**PROPOSED EXPLANATION OF SIGNIFICANT DIFFERENCES  
FORMER SUPERIOR TUBE COMPANY FACILITY  
EVANSBURG, PENNSYLVANIA**

Figure 1: DNAPL Area

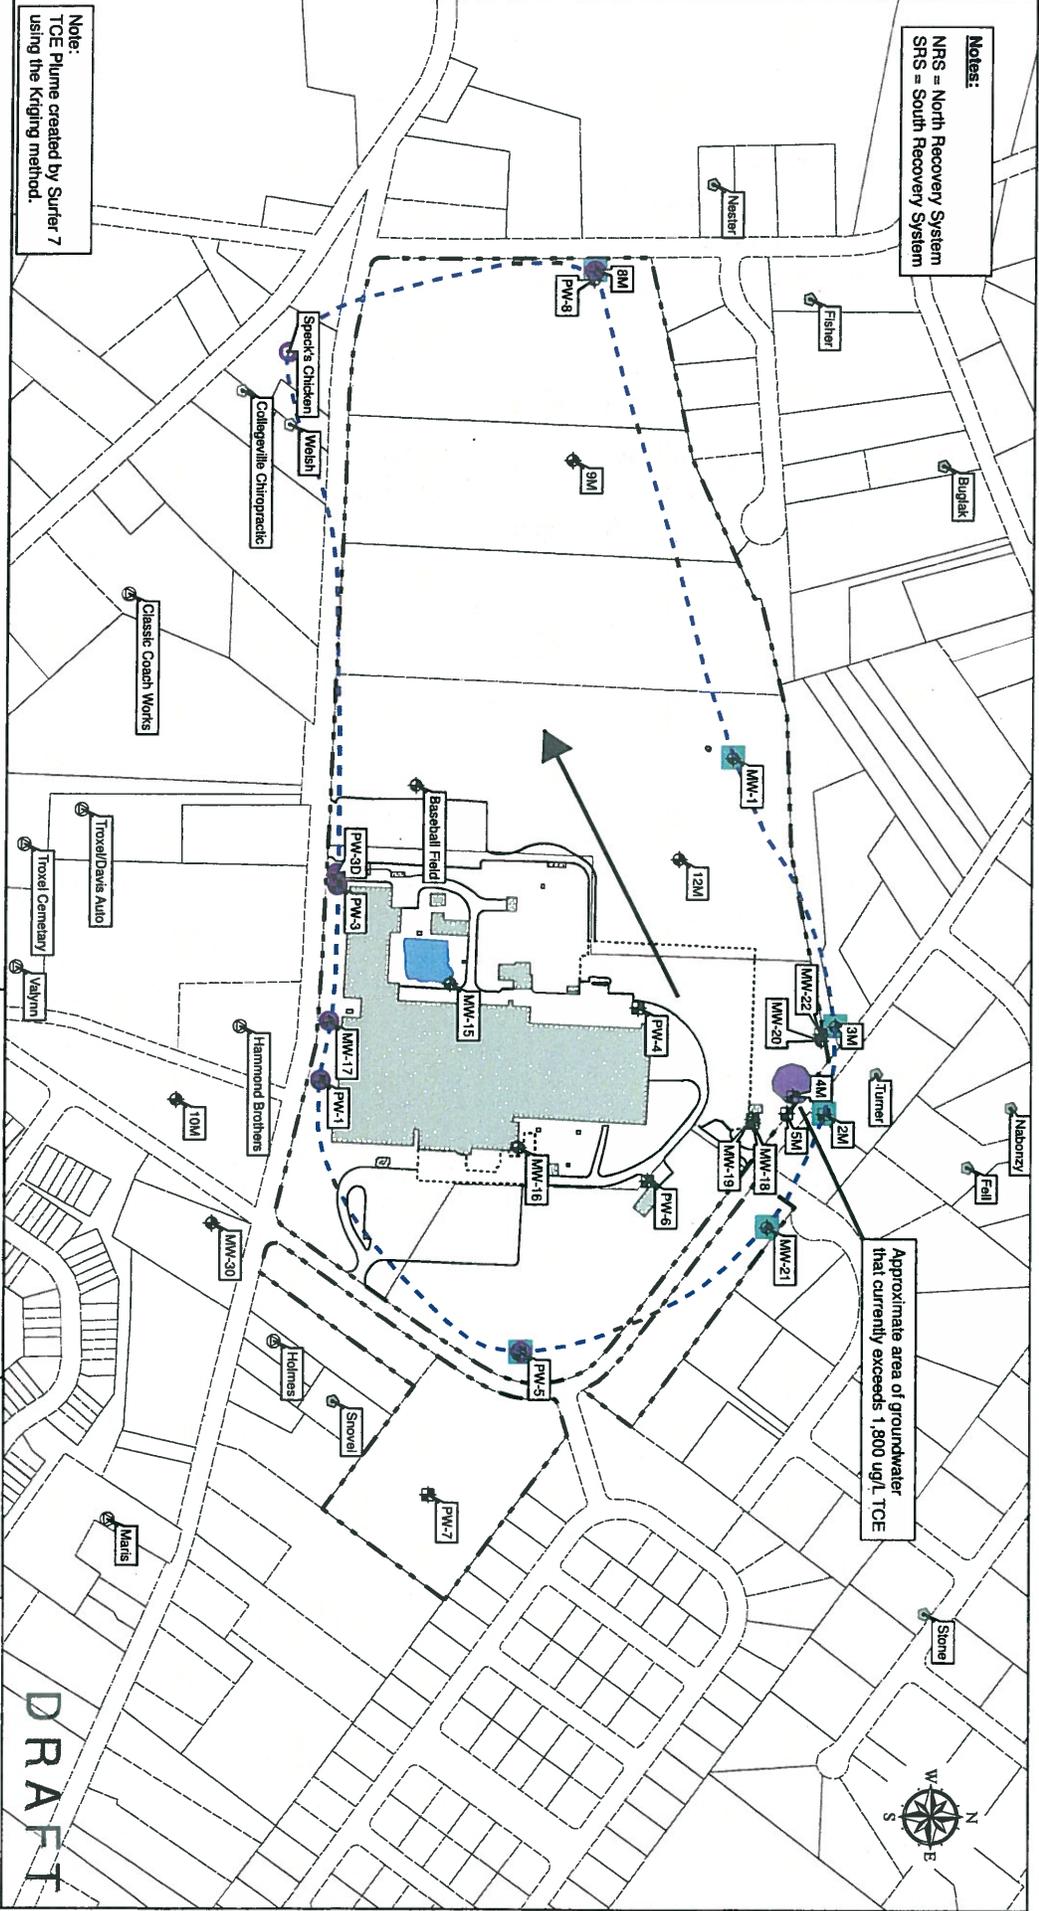
This proposed ESD modifies EPA's cleanup goal for TCE; PCE; cis-1,2-DCE; trans-1,2-DCE and vinyl chloride from their respective MCLs to their respective SSSs within and in the proximity of the Facility property boundaries (DNAPL Area) as presented in the attached Figure

1. EPA has determined that the continued implementation of the ISVE and groundwater pump and treat systems selected in the FDRTC are not likely to achieve the MCLs for those COCs in the DNAPL Area within a reasonable or foreseeable time frame due to technical impracticability from an engineering perspective. ISVE and groundwater pumping and treating have greatly reduced the concentration of those COCs in the groundwater, but has shown to be incapable of reducing the concentration of those COCs to their MCLs. Any technology capable of removing the DNAPL in such an environment would first have to mobilize the DNAPL and, then, have to extract the mobilized DNAPL. No known technologies are capable of extracting DNAPL from the fractured bedrock geologic system. Moreover, any attempt to remobilize the DNAPL may cause ecological and human health risks which do not currently exist.

<u>Contaminants of Concern</u>	<u>SSS Cleanup Goals (micrograms/liter)</u>
TCE	1,800
PCE	3,500
cis-1,2-DCE	9,300
trans-1,2-DCE	7,700
Vinyl Chloride	180
